Addendum #	02	Date Issued	03/31/2025
Project Name Job #	SWN 0509, Waneta Hall Renovate Restrooms	OSE # R0325--15X	EAPC #20256780
Bid Date Time	April 3, 2025		3:30pm

THIS ADDENDUM AMENDS AND BECOMES PART OF THE CONTRACT DOCUMENTS FOR EAPC PROJECT 20246780 DATED 03/13/2025, RESPECTIVELY. EACH BIDDER SHALL ACKNOWLEDGE RECEIPT OF THIS ADDENDUM BY MARKING THE ADDENDUM NUMBER AND DATE ON THE BID FORM.

M303

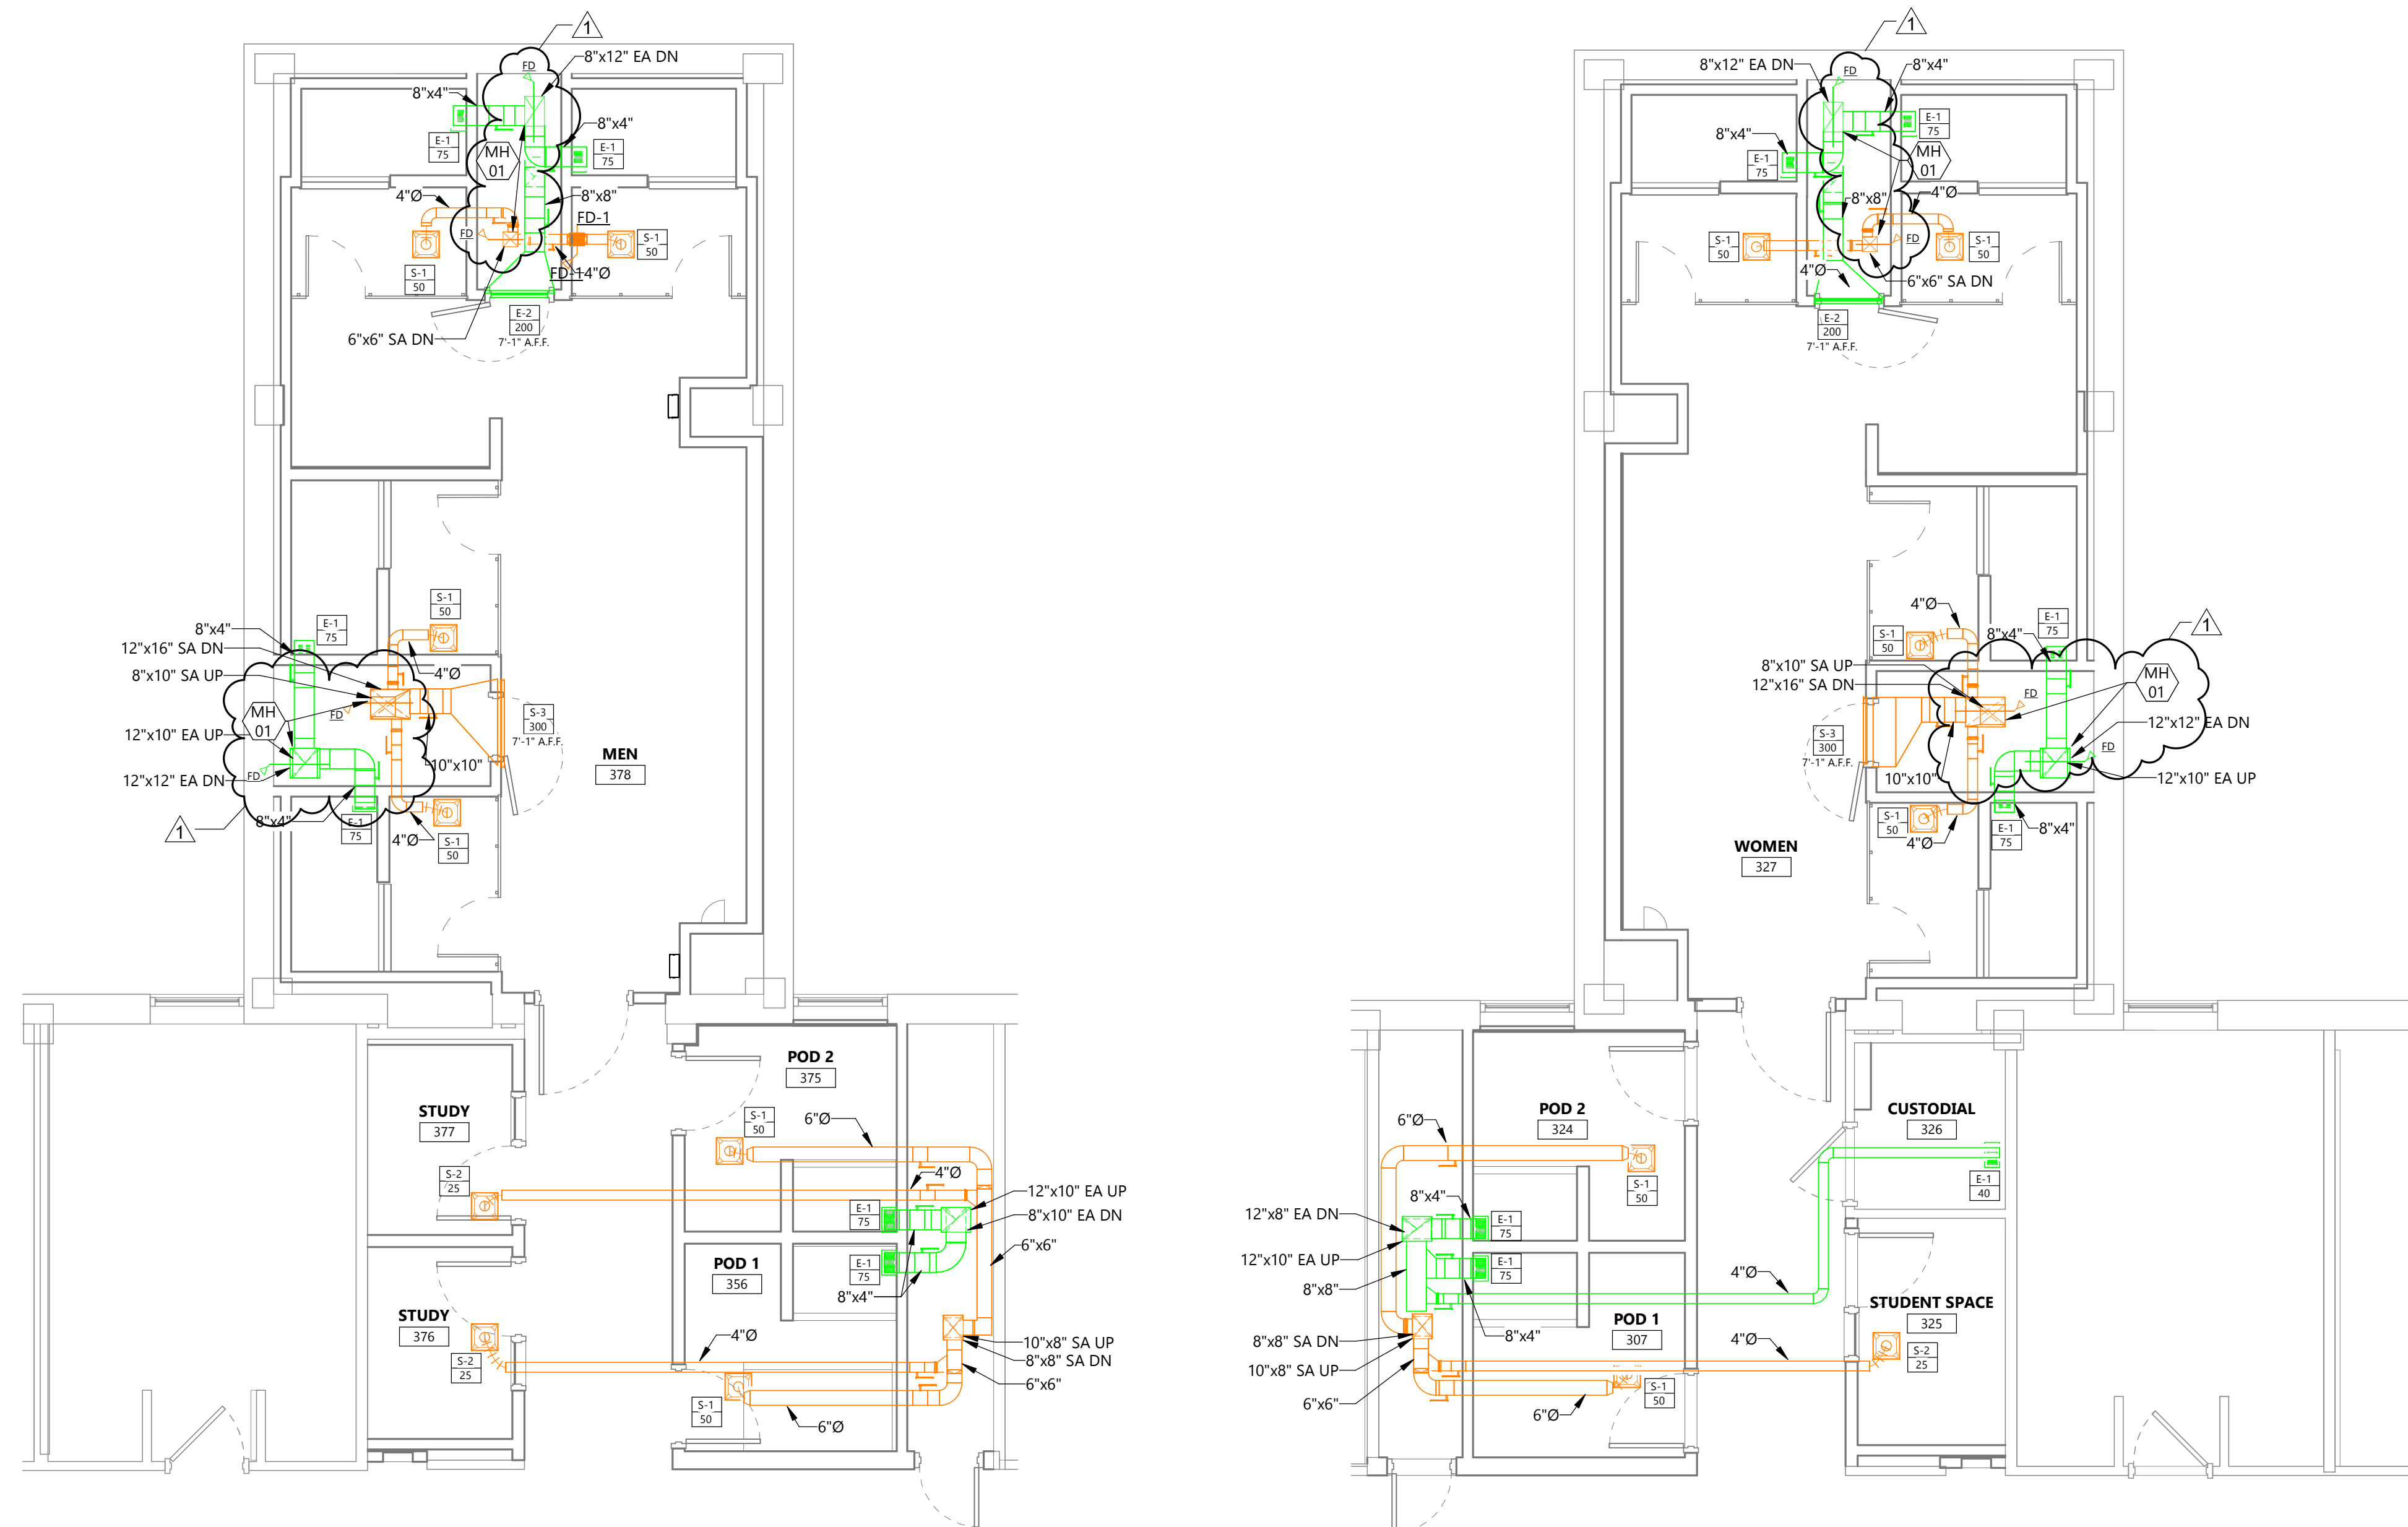
- M303 ADD General Note 01 regarding sealing annular space at all floor and ceiling penetrations between floors with noncombustible material to resist the passage of fire and smoke. ADD fire dampers at floor assembly between second and third floor as shown on plan.

DRAWING TITLE
DEMOLITION PLAN - ADD ALTERNATIVES

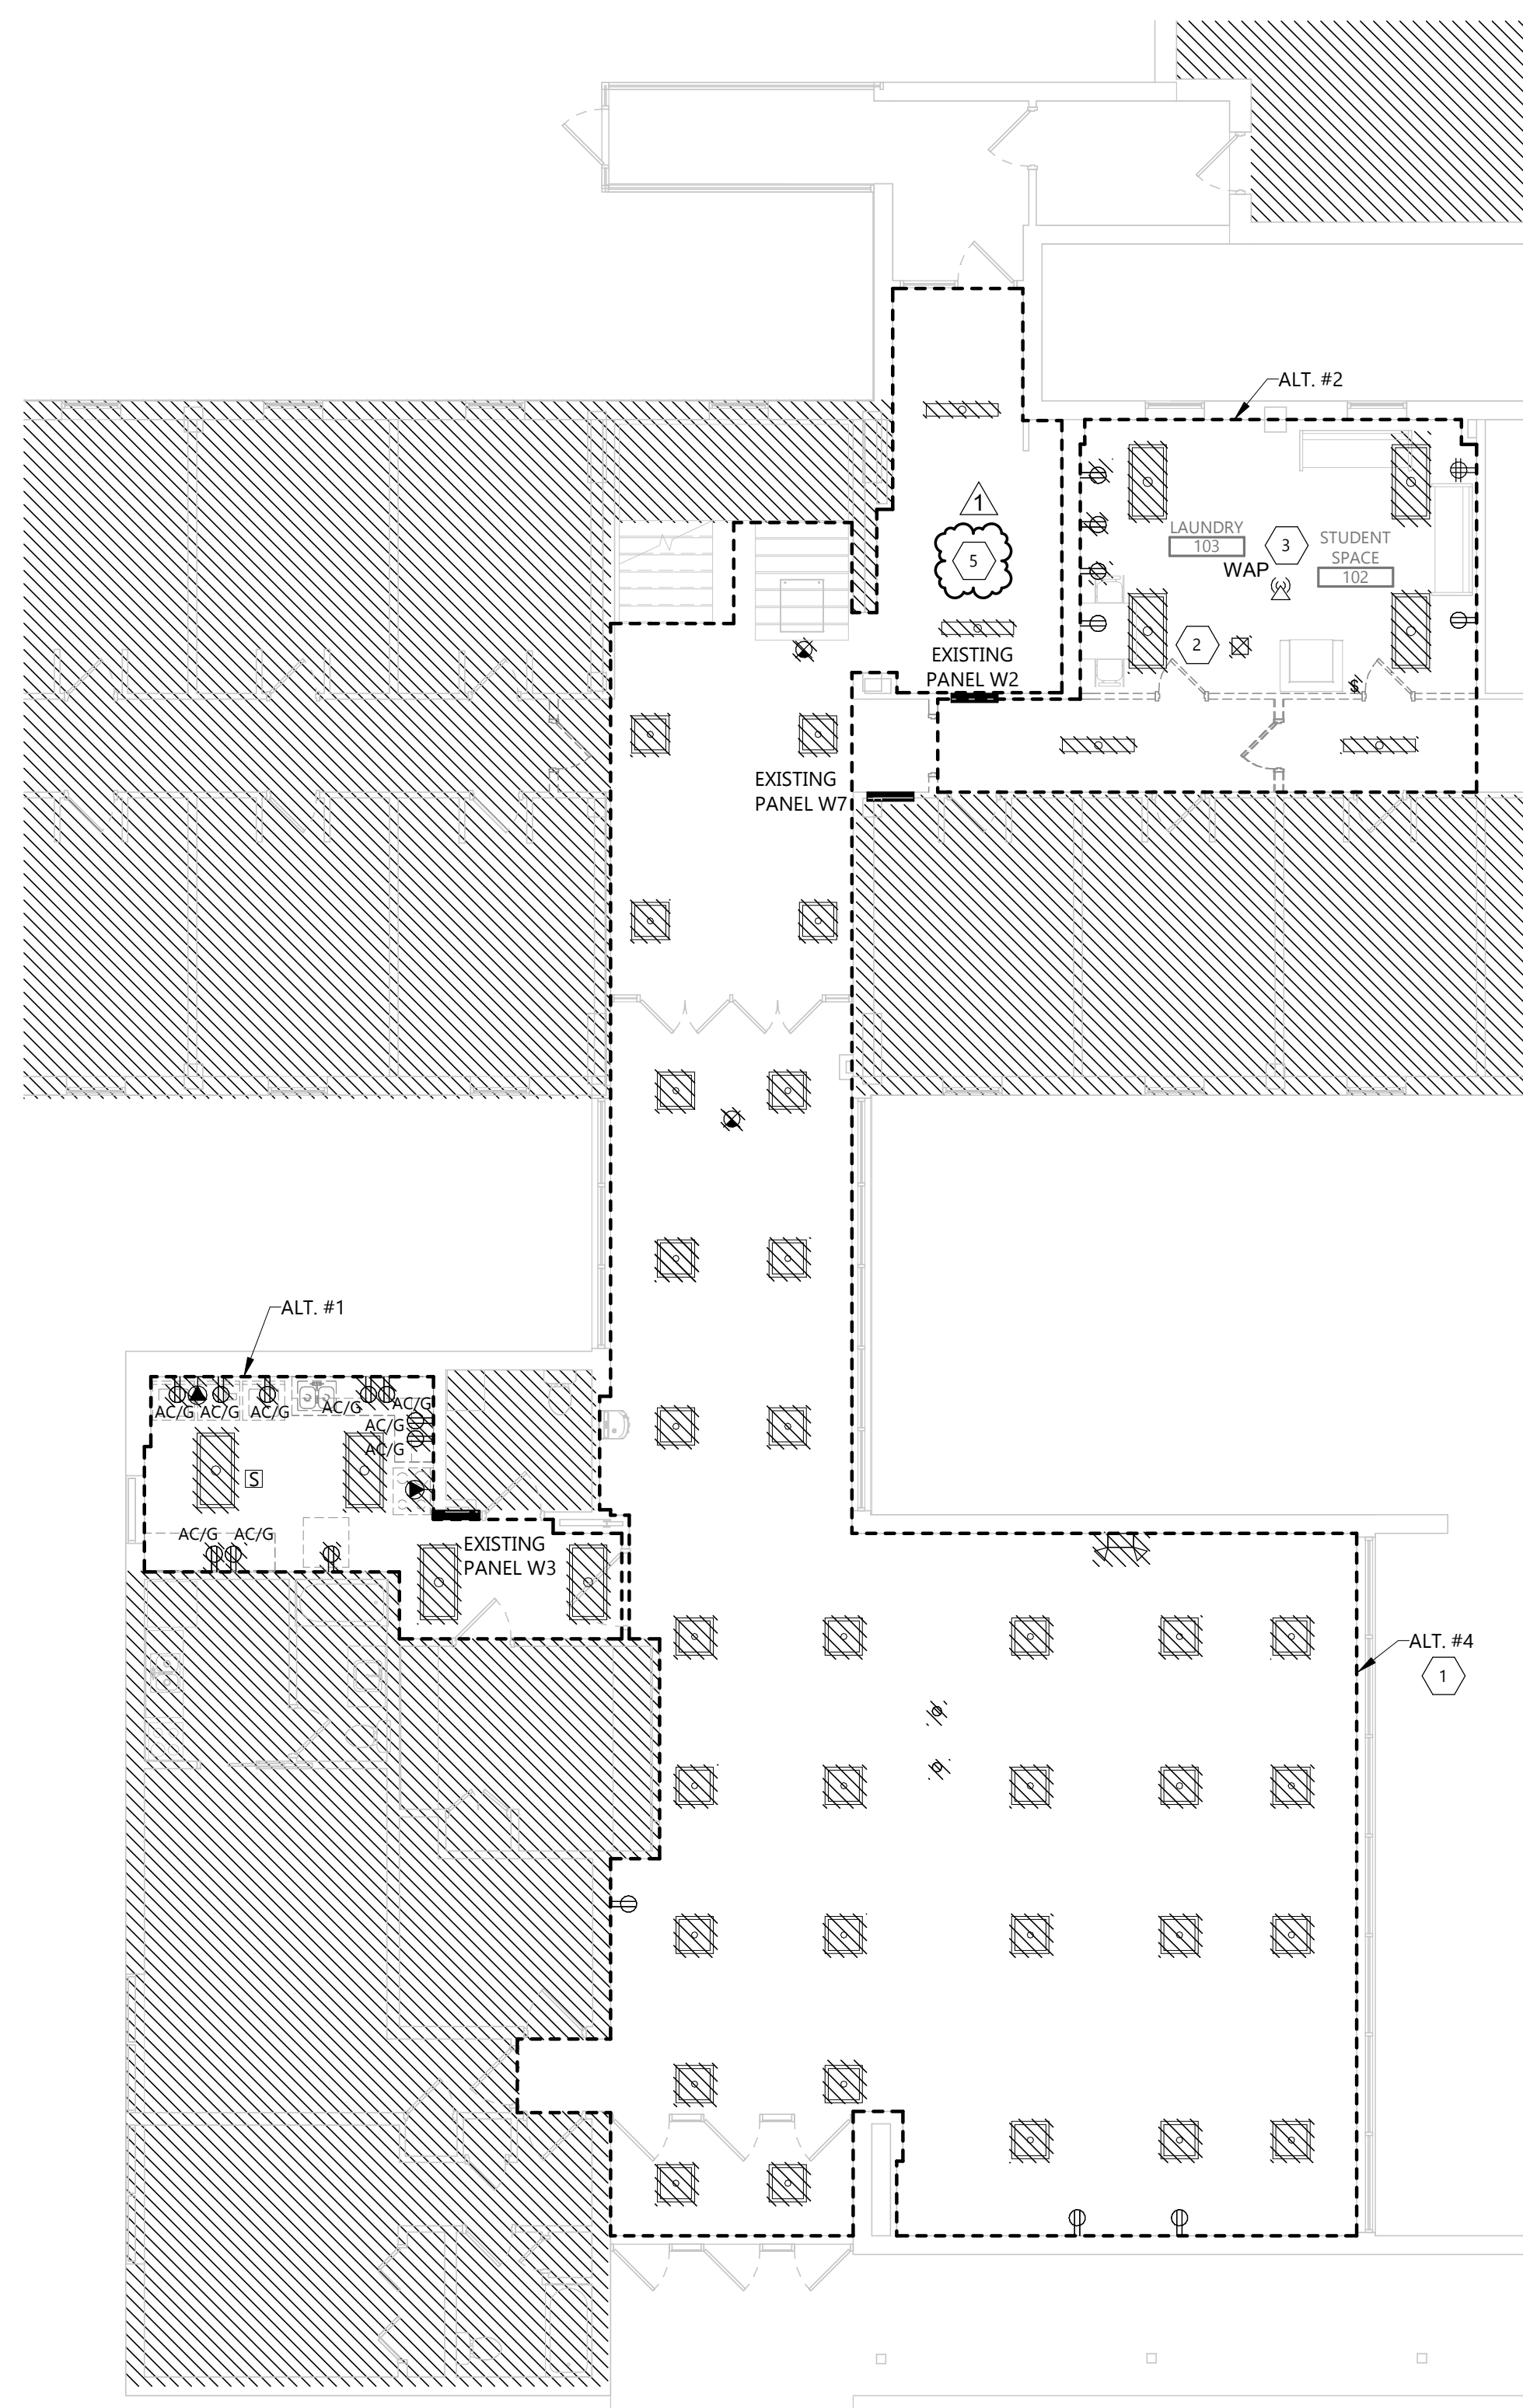
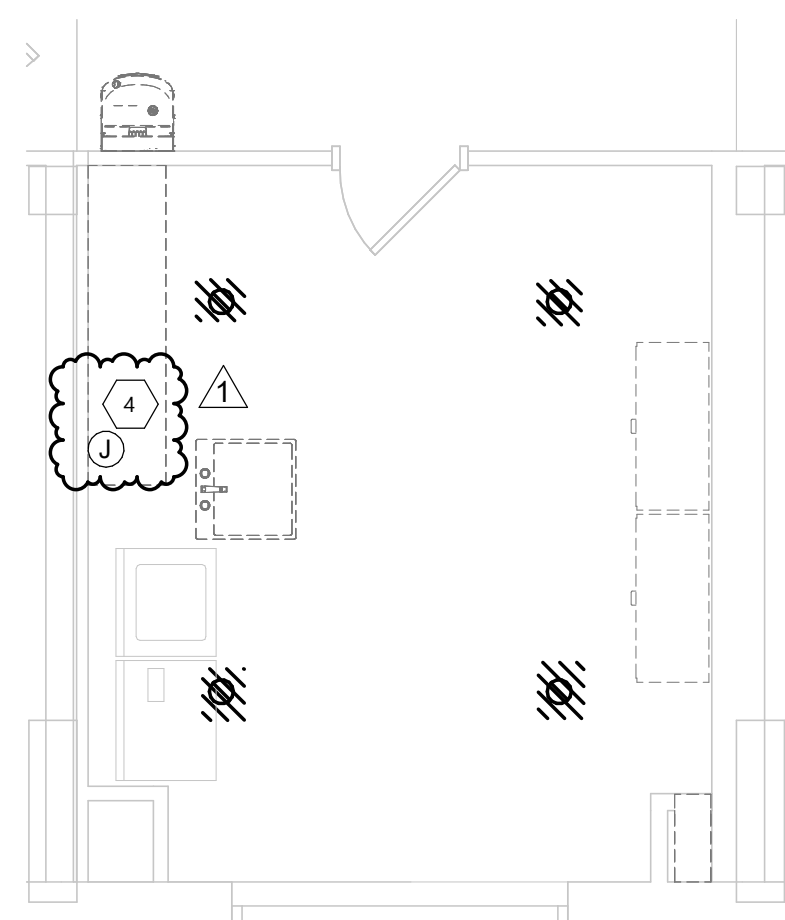
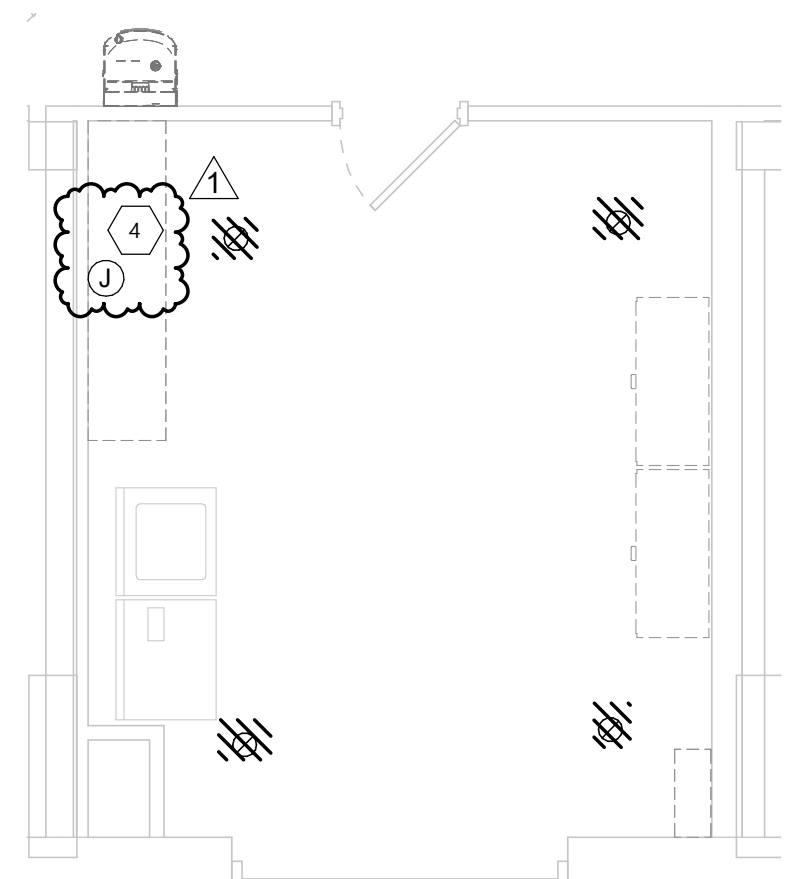
- M304 CLARIFICATION: All outdoor ductwork shall be pre-assembled phenolic type (see specification).
- E104 Clarification for 2nd and 3rd floor laundry rooms that require relocation of data panel. Add note 5 for entry way for added ceiling.
